<b>Document Title</b>		<b>PACKAGE OUTLINE, 144L CSBGA, 10x10x1.4mm</b>			
<b>Doc ID #</b>	<b>21-0169</b>	<b>New Rev</b>	<b>B</b>	<b>Effective Date</b>

TITLE: PACKAGE OUTLINE,  
144L CSBGA, 10x10x1.4mm

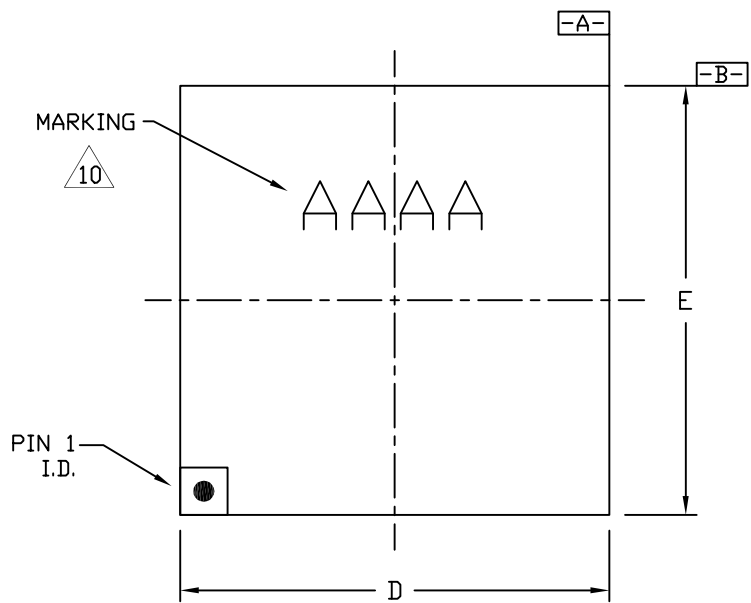
Revised the ball diameter (b) dimension
---

From	To
Ball diameter (b) dimension = 0.50mm nominal	Ball diameter (b) dimension = 0.45mm nominal
